# United States Patent and Trademark Office

APPLICATION NO.	FI	LING DATE	FIRST NAMED INVENTOR	ATTORNEY DOCKET NO.	CONFIRMATION NO
10/075,597	02/15/2002		Roy Sanders	2880/360	9386
23838	7590	04/05/2005		EXAMINER	
KENYON (			ROBERT, EDUARDO C		
1500 K STREET, N.W., SUITE 700 WASHINGTON, DC 20005				ART UNIT	PAPER NUMBER
	,			3732

#### **DETAILED ACTION**

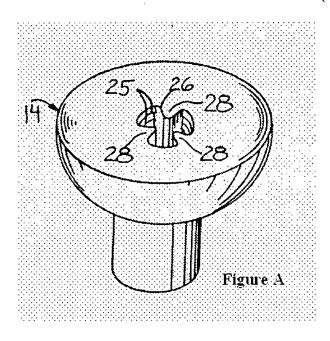
Tormala et al. disclose a surgical screw which is bioabsorbable in vivo and comprises an elongated shank with threads, a head perpendicular to a longitudinal axis of the shank, and the shank protruding from the head (see Figure 3 below). The head comprises a recess which can be any shape as shown in Figures 4A-4C, e.g. 51, 54, 52, 55, 53, in the proximal surface and the recess has a cross-section with a rotational symmetry around the longitudinal axis of the shank and wherein the recess has an odd number of rounded lobes, i.e. 3, extending away from the center of the head. The screw comprises self-reinforced material (see col. 7, lines 20-23). The head has a distal surface that tapers toward the shank (see Figure 3 above). With regard to claim 3, it is noted that the screw of Tormala et al. is made by machining (see col. 7, lines 34-35) and

this includes clearly the formation of the recess. Tormala et al. disclose the claimed invention except for the recess having a shape that includes lobes that are ovals, circular or rectangular with rounded edges. Yamamoto discloses a surgical screw with a recess having a shape that includes lobes that substantially resemble an oval (see Figure 7). One of the purposes of having a recess, as shown by Yamamoto, is to provide the screw with a high and stable conversion efficiency of torque. It would have been obvious to one skill in the art at the time the invention was made to construct the screw of Tormala et al. with a recess in view of Yamamoto, in order to provide the screw with a high and stable conversion efficiency of torque.
